ADDENDUM NUMBER TWO

SWIM TEAM LOCKER ROOM RENOVATIONS
UNIVERSITY OF SOUTH CAROLINA
COLUMBIA, SOUTH CAROLINA

DATE OF ISSUE: May 12, 2014

2 SECTION AT WOMEN'S SHOWER AREA
 A3.3R 1/2" = 1'-0"
 REFERENCED ON: A3.3R

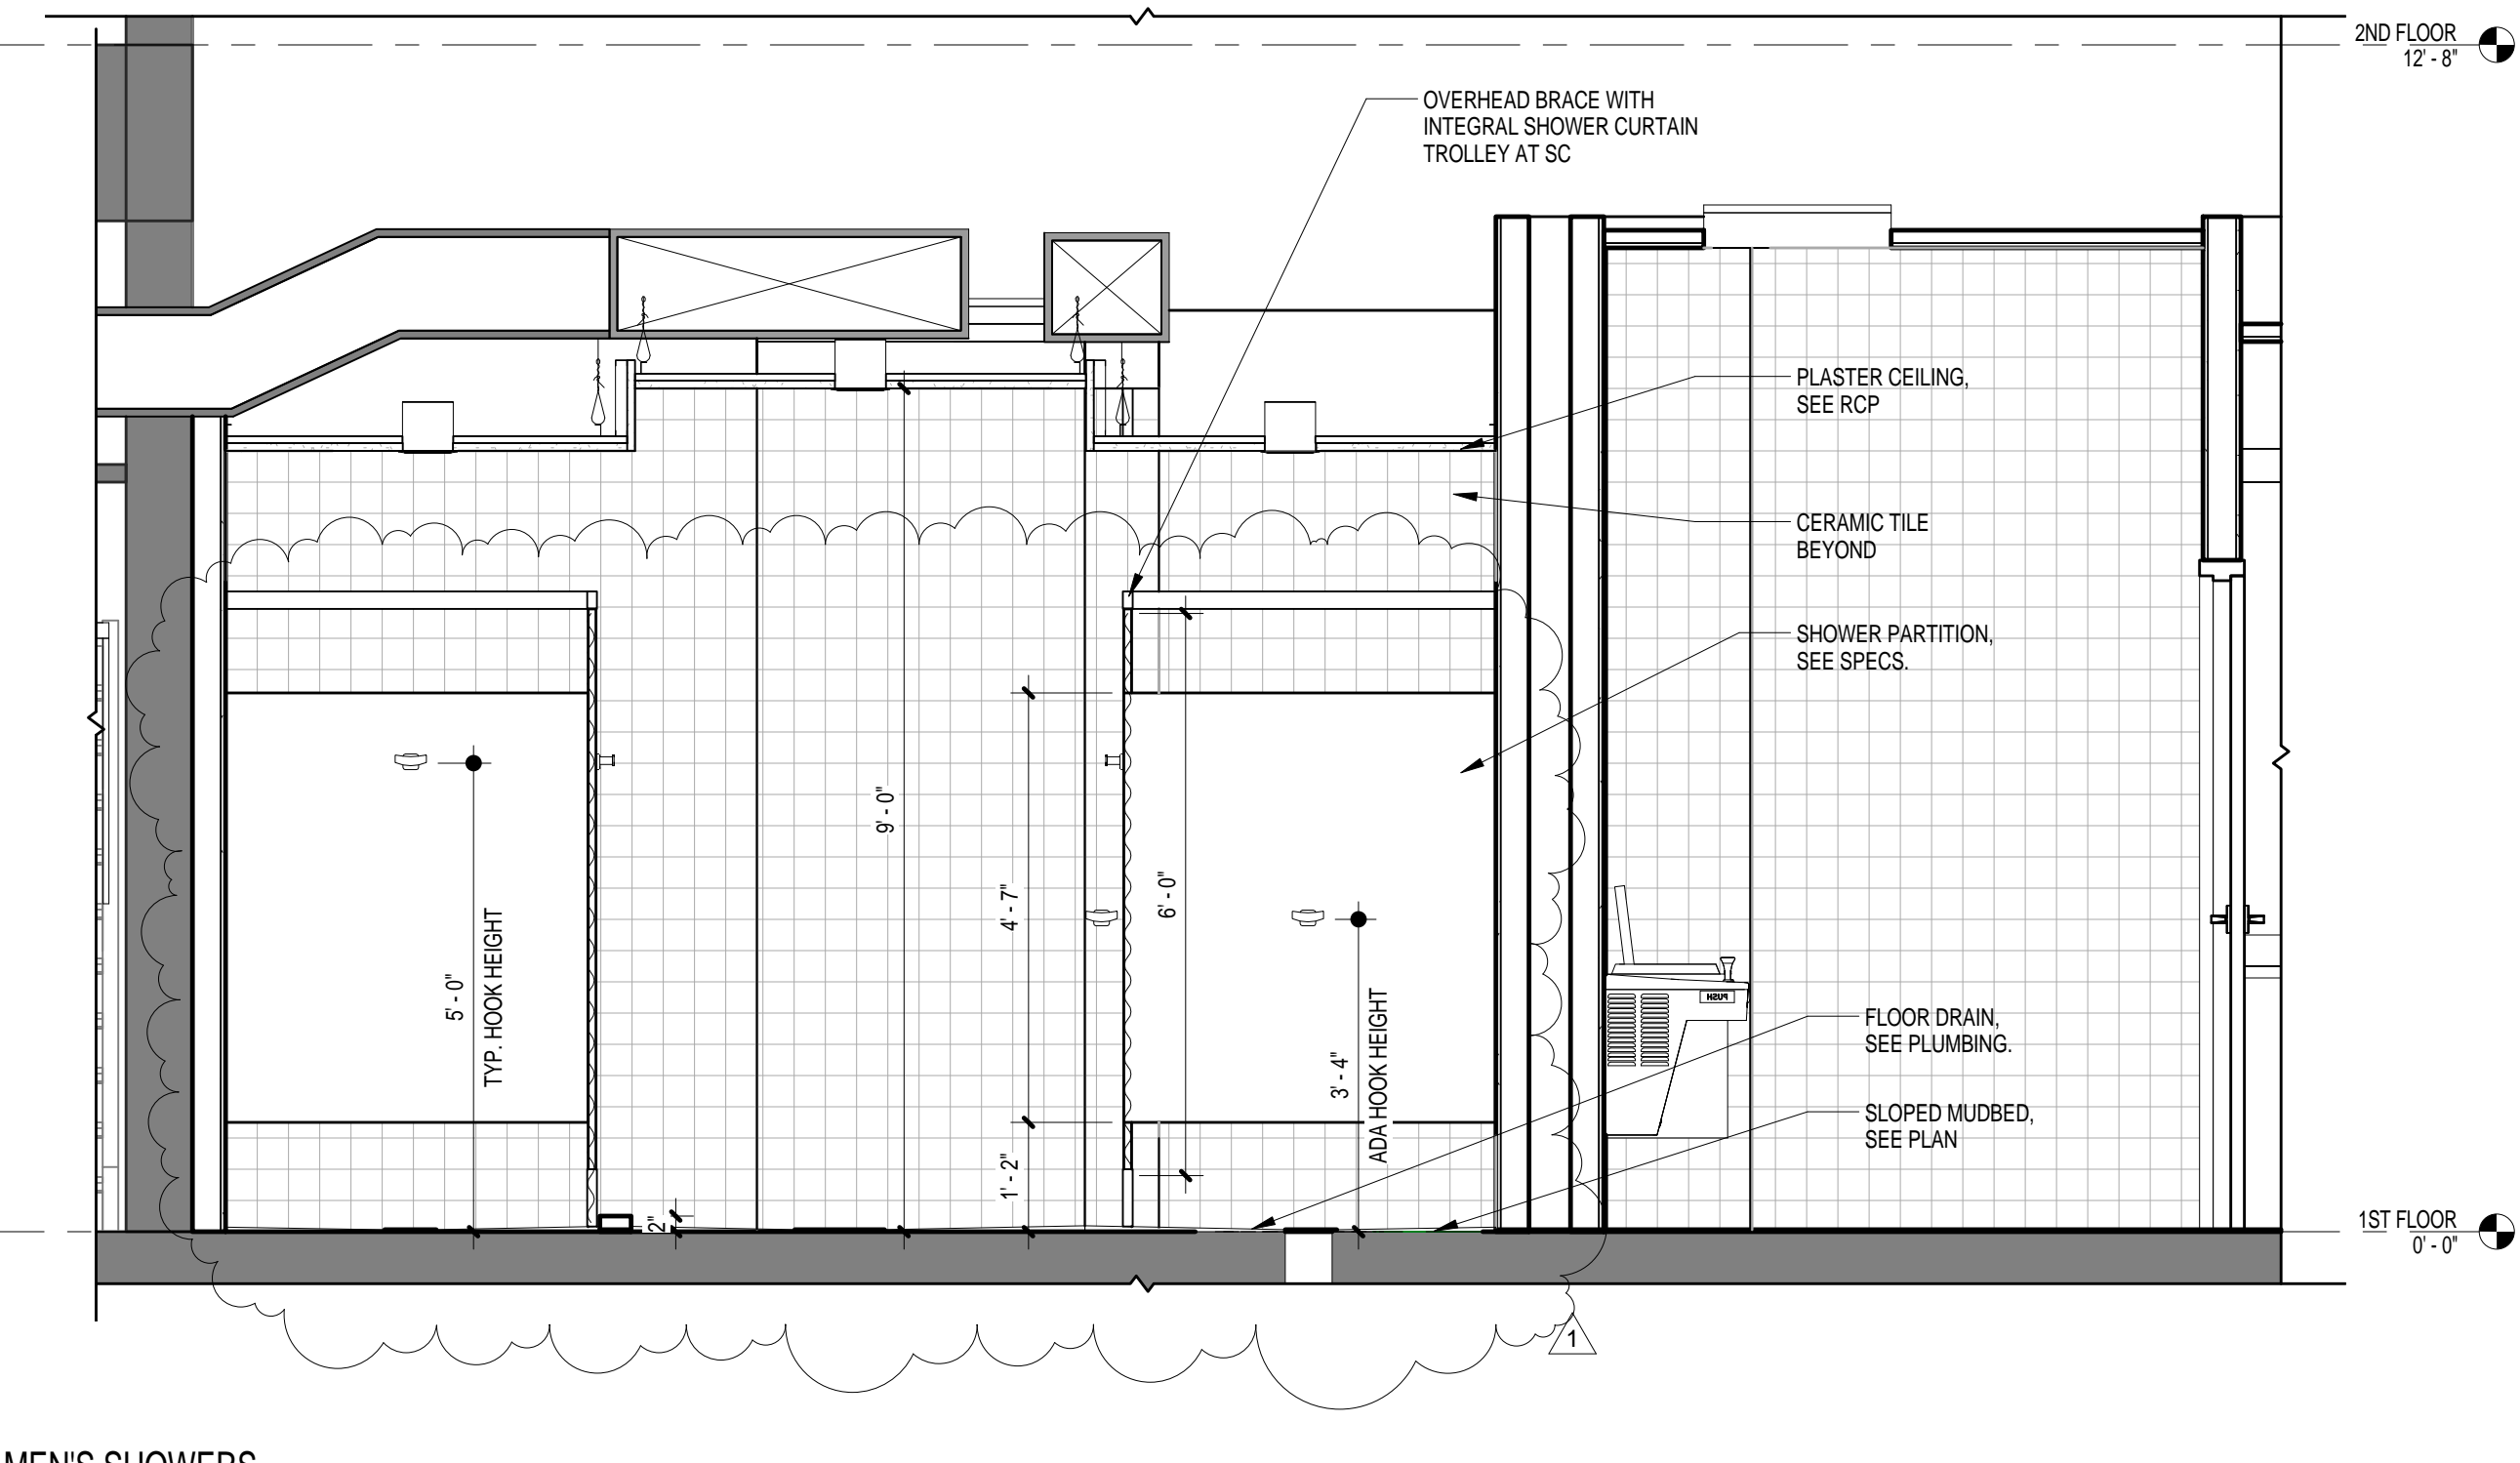
1. **Revision:** Delete Sheet A2.1 and E2.1 from Bid Documents. Replace with attached A2.1R and E2.1R. See revised base bid lighting layout in Women's Locker Room 136, Team Room 136F, and Men's Locker Room 127. See attached sketch SKE1 for light fixture schedule revisions.
2. **Revision:** Add Alternate No. 3 to Bid Documents. Add sheets A2.1A and E2.1A to Bid Documents. Provide Alternate No. 3 lighting layout in Women's Locker Room 136, Team Room 136F, and Men's Locker Room 127. See attached sketch SKE1 for light fixture schedule revisions.
3. **Revision:** Delete Sheet A3.3 from Bid Documents. Replace with attached A3.3R. See revised shower compartment/ shower curtain layouts and heights.
